# FINDLAY CITY PLANNING COMMISSION

## STAFF REPORT December 14, 2017

Thursday, December 14, 2017 - 9:00 AM

# CU-04-2017

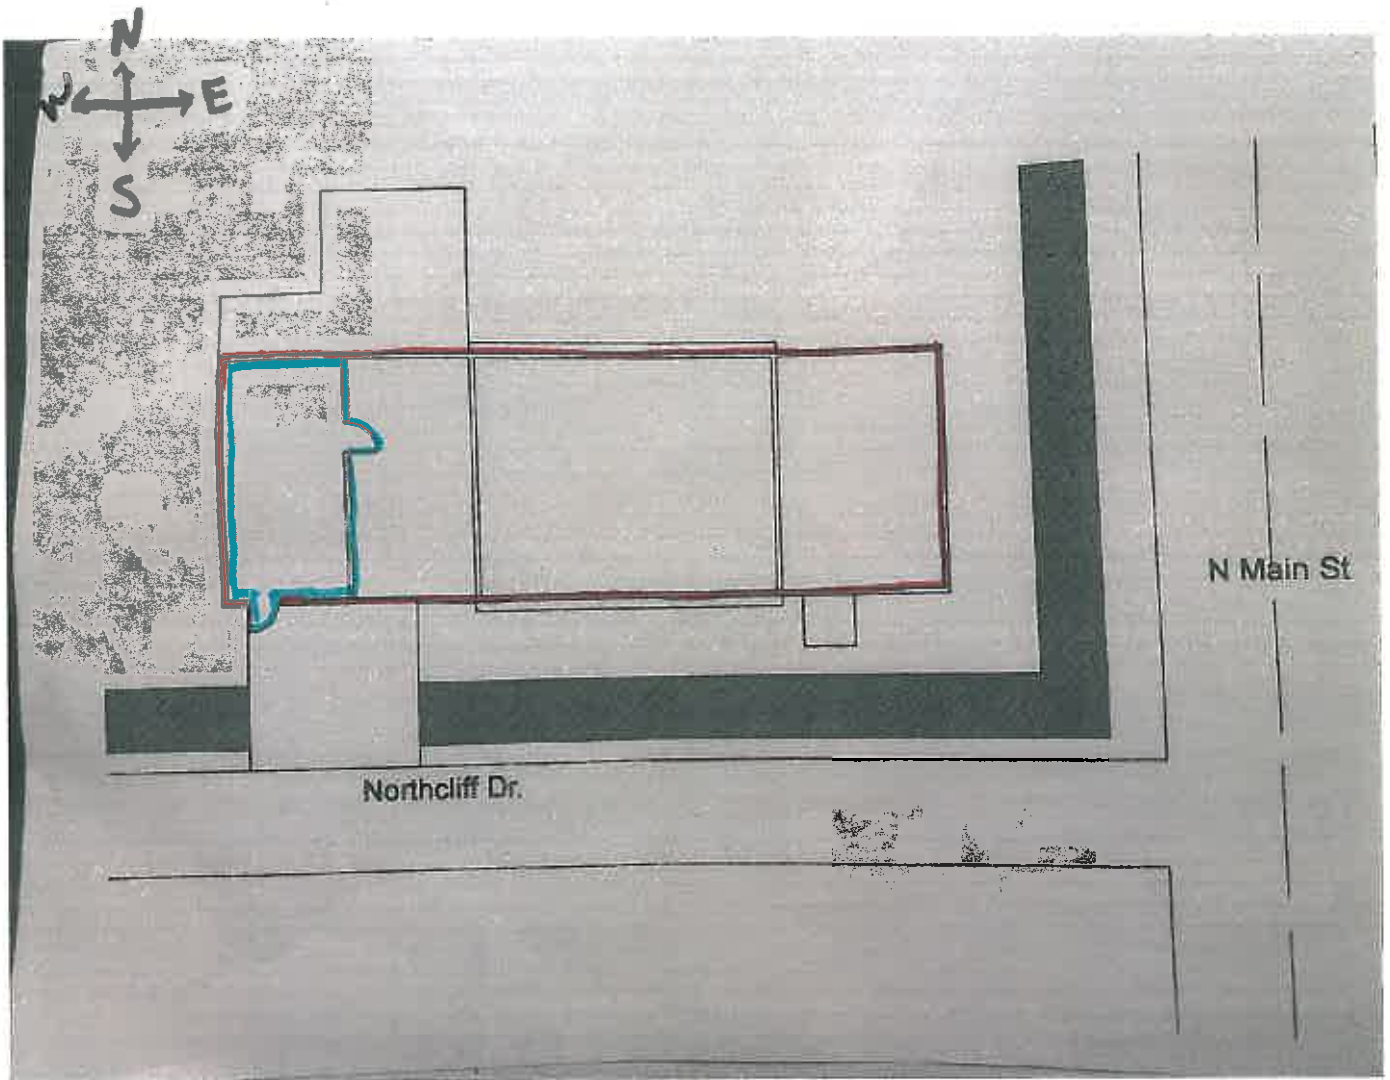
Section 1161.15 C under CONDITIONAL USE REQUIREMENTS has conditions, which may be imposed by CPC for approval of Home Occupations. #3 states that the garage is not considered as part of the home to be used for home occupations. #4 states that there are to be no additional or separate exterior entrances to the dwelling specifically used for the purpose of conducting business or to accommodate the home occupation. The plan submitted is using the garage as the site of the business and it appears that one garage door is being eliminated and an entry door is being added in its place specifically for the business.

While Staff does not have issue with the use of the attached garage we do feel that it is a change

in the character of the residential appearance once a garage door is removed and a new entry door is installed and sets that section apart as something different. The intent of Home Occupations is to remain virtually invisible in the overall residential aesthetics of the neighborhood.

Would like a little bit more information on sanitary sewer for the shop. Will dogs be washed in the shop; how will the feces be taken care of? If dogs are washed in the shop, is the drain tied into the sanitary sewer, and how is dog hair being kept out of the sanitary sewer?

Dog feces break down different than human, so dog feces cannot be released into the sanitary sewers.

**PROPOSED SITE PLAN**

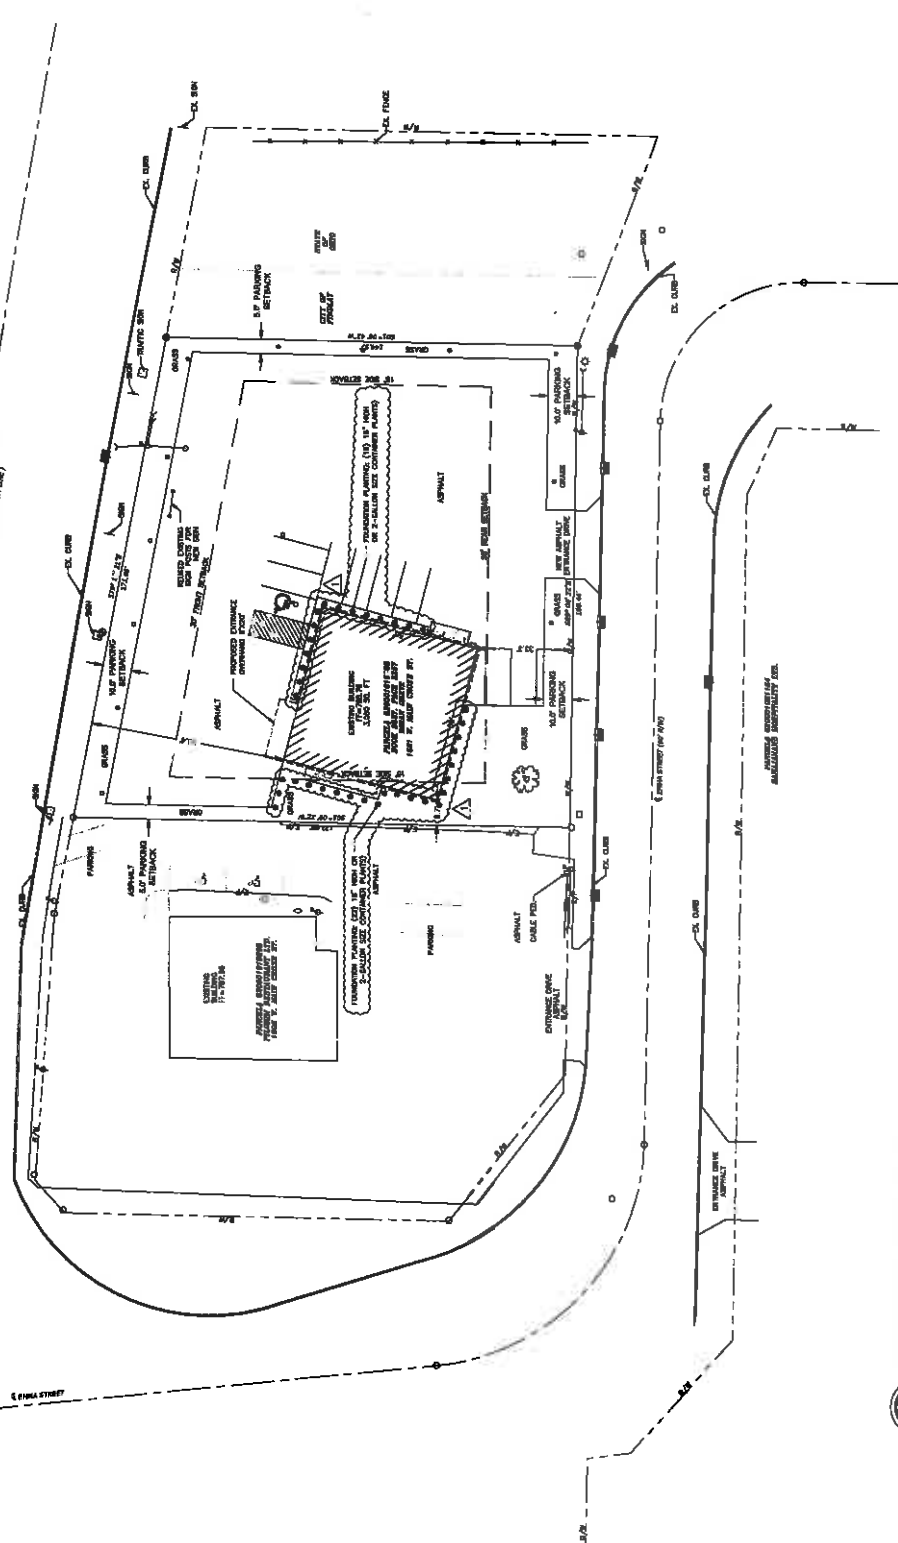
The applicant is proposing to demolish the front portion of the existing building leaving a 56' x 55' structure and repave the majority of the lot in order to use as a used car dealership.

Setbacks in the C-2 district are 30' front, 15' side and 30' rear. The west side encroaches into the setback, but it is an existing condition and therefore grandfathered.

The building is well below the 60' maximum permitted in the C-2 district. Elevation drawings show the height at approximately 16'-8"

The easternmost drive entry is being relocated east of the existing one. It currently sits directly behind the building.

There are nine (9) parking spaces shown on the plan around the building. C-2 requires one space per 375 square feet of building. The building is 3080 square feet and the nine (9) parking spaces meets the minimum requirement.

Light poles are located around the perimeter of the site. The plan states that the poles will be at the maximum of 25' in height. Because the poles are located so close to the property lines, the foot candle readings are higher there. Because all the abutting uses are also commercial, we do not see an issue with these. The only potential adverse effect might be for the motel clients to the south. The readings do not go to that property, but from the readings indicated on the plan it would make sense that the intensity should dissipate by the time it gets to the motel.

Foundation plantings are shown on the plans. The front page of the packet has some language related to the general landscaping standards in C-2. Parking lot landscaping (1161.06.3) will also apply to this site. This planting is permitted in the setback areas.

There is an existing sign location indicated. The comments stated that they would use the existing poles for their sign. The applicant has been in contact with Todd Richard on the repurposing of the poles to bring it in to compliance with the sign standards.

*Access* – Access to the site will be from a new drive coming off the north side of Emma St. The existing drive will be removed and new full height curb will be placed in the previous drop location. A new drive will be installed to the east of the removed drive, with new curb and asphalt.

*Waterline-* There are no proposed waterlines shown on the plans, the existing tap will be reused.

*Storm Sewer-* There is no proposed storm shown on the plans.

*Sanitary Sewer-* There are no proposed sanitary sewer shown on the plans, the existing lateral will be utilized. It is recommended that the existing lateral be video inspected, before making any final connections. The line has been sitting idle for a couple years, and should be checked before proceeding.

- The new portion of curb will need to have the forms inspected before concrete is placed.
- Backfill in front of the proposed curb must be 3000# concrete, and topped with 1.5-2 inches of hot mix asphalt.

***Recommendations:*** Approval of the Site Plan subject to storm water details being approved by City Engineer.

# SP-24-2017

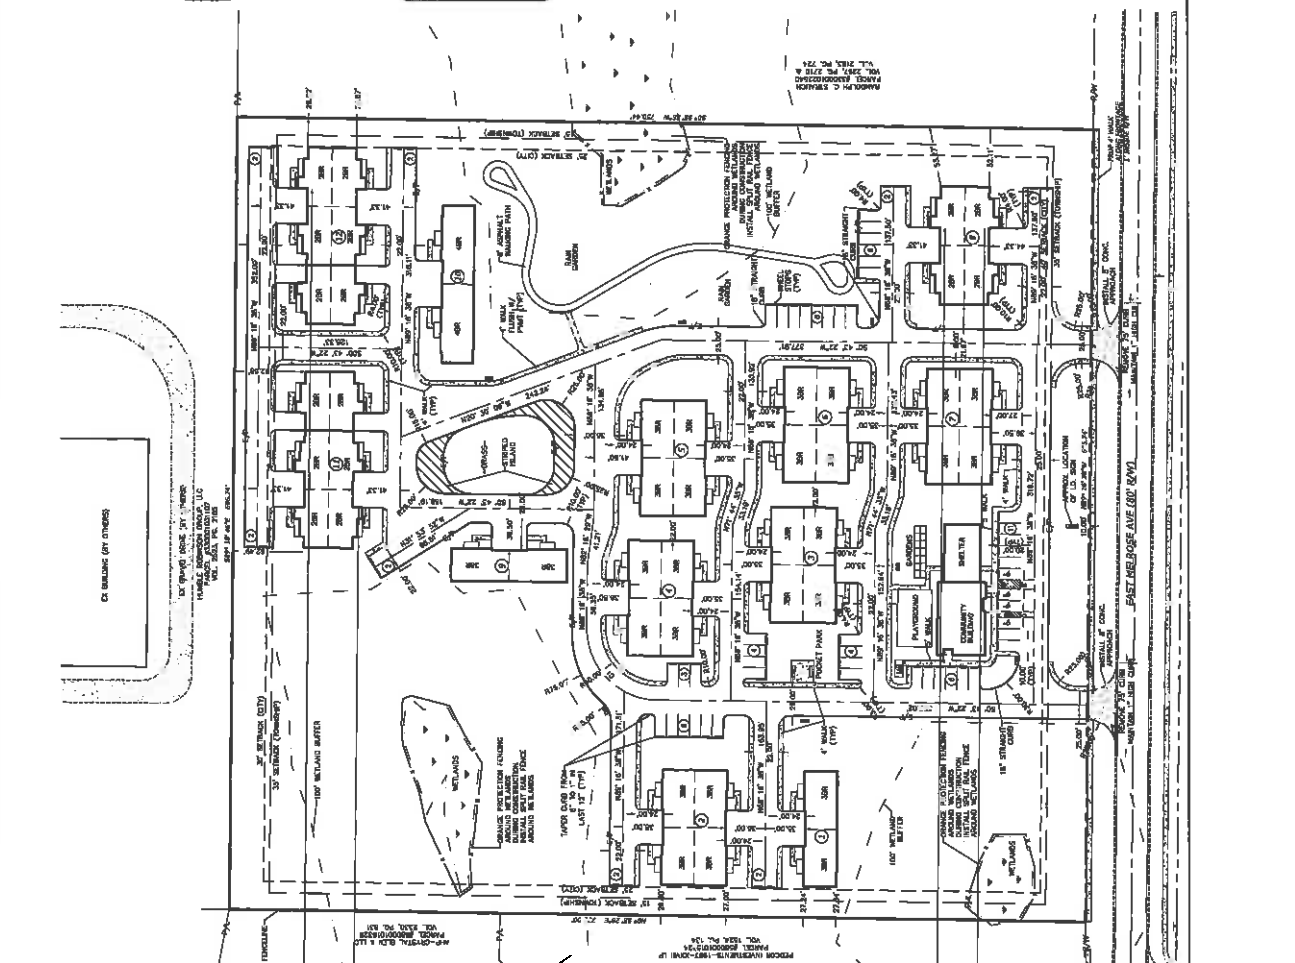
The applicant is proposing to construct 12 apartment buildings with a total of 46 units and a community building on a 12 acre site. The parcel is currently 24+ acres. A lot split will be required to create the proposed parcel. There are seven (7) 4-unit buildings, three (3) 2-unit buildings and two (2) 6-unit buildings. Sixteen units are 2 bedroom, two units are 4 bedroom and twenty eight units are 3 bedrooms. All buildings are single story.

The applicant has shown both the City of Findlay and Marion Township setback lines. The applicant intends to annex the property to the City, but depending on when they would start the project they could have to obtain their permits from the Township. We will review based on the City of Findlay zoning ordinance. Setbacks in M-2 in the City are 40' front on a Secondary Thoroughfare, 25' sides and 30' rear. All setbacks are met. The 20' minimum spacing between buildings is also met.

The M-2 Multiple Family District requires that no more than 40% of the site be impervious surface. The developer has calculated the impervious area at 39.9%. The district also had a density requirement of 3500 square feet of lot area per unit. The 46 units proposed is well under the maximum density allowed which could be as high as 149 units.

Parking for multiple family developments is calculated at 2.5 spaces per unit. 46 units require 115 parking places. The proposal shows a total of 160 parking spaces. There are 48 parking spaces inside garages, another 48 in the driveways and various small parking rows scattered through the site with another 64 parking spaces in them.

There are a few wetland areas on the site. The main grass areas are located around these. There are other smaller pockets of green areas around each building. A playground and community garden is located on the north side of the community building. An asphalt walking path is provided in the large greenspace area on the east side of the site.

The landscaping plan submitted shows considerable foundation plantings around all structures and adequate perimeter landscaping. Additional trees are planted in the "park" areas.

Identification signage is shown in the grass area between the two drive entrances for the complex. It is located 10' from the right-of-way line as required. Details of the sign must be submitted to the zoning department for approval and a permit.

The photometric plan submitted for the site shows foot-candle readings at zero at all property lines. Lighting specifications submitted show lantern type fixtures to be pole mounted. There are specifications for various pole heights in the specs and all would be under the 25' maximum height. We would like the developer to provide the specific height they intend to install.

*Access* – Access to the site will be from two concrete approaches off the north side of E. Melrose. These new drives will be 75 LF wide each with sidewalk going through them. The driveways are roughly 317 LF apart

*Sanitary Sewer* – The plans propose a sanitary sewer to be run from an existing manhole on the east side of the site. The 8-inch sewer will run within the right of way towards Crawford Station for about 550 LF. There are no easements shown on the plans, so it is assumed that the 8-inch sewer running within the ROW will be a public line and all sanitary sewer outside of ROW will be private.

*Waterline* – The plans propose a waterline to be tapped onto the existing 12-inch line that is located on the south side of Melrose. An existing 24-inch concrete pipe will be utilized as a carrier pipe for the new waterline. There are no easements shown on the plans, so it is assumed that the 8-inch waterline will be all private.

*Storm water Management* – Detention for the development will be provided by the existing regional retention pond in the Deer Meadows Subdivision. The site will drain to an existing storm sewer located along E. Melrose Avenue.
